# Gladstone Nickel Project Environmental Impact Statement Supplement

**Volume 1 • Main Report**

**Gladstone  
Pacific Nickel LTD**

February 2008

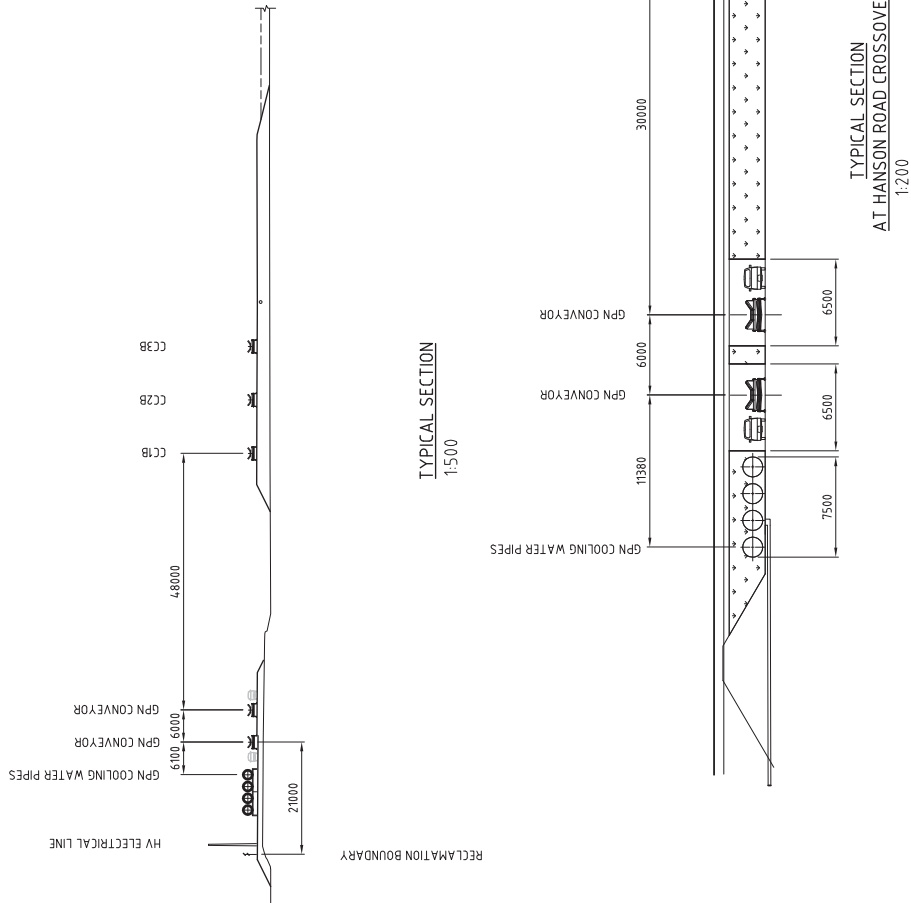
The Department of Main Roads (DMR) advised that the EIS provides insufficient information about the construction of the seawater pipes, materials handling facility and materials conveyor/s for transportation of materials, to allow DMR to judge whether road impacts of project traffic are adequately dealt with. As required by s2.2.1 ToR, the EIS must provide sufficient information about these elements of the project in terms of:- location/ physical interaction of the pipelines/conveyor with Hansen Rd e.g where they cross; - volume of construction inputs and resulting traffic generation; - assess road safety and efficiency impacts of the above traffic; - adverse impacts on DMR's plans for future duplication of Hanson Road. The EIS should also detail proposed mitigation strategies following consultation with the DMR district office.

The ore and sulphur conveyors will pass under Hanson Road in the same manner proposed for the conveyors for the WICT. The refinery discharge pipelines will also pass under Hanson Road. A typical cross-section of the Hanson Road crossing is shown on Figure 2.1(a).

The planned crossing of Hanson Road will allow for the road's duplication and will be undertaken in such a way so as to minimise detrimental affects on traffic flow. This will be achieved by undertaking construction of the widened road corridor for a predetermined length and to a higher road level. During the construction of this widened portion of the road, a series of culverts and slabs will be constructed within the embankment to provide the necessary clearance for the sub-road structures which will contain the conveyors and pipelines as well as maintenance access and other related services.
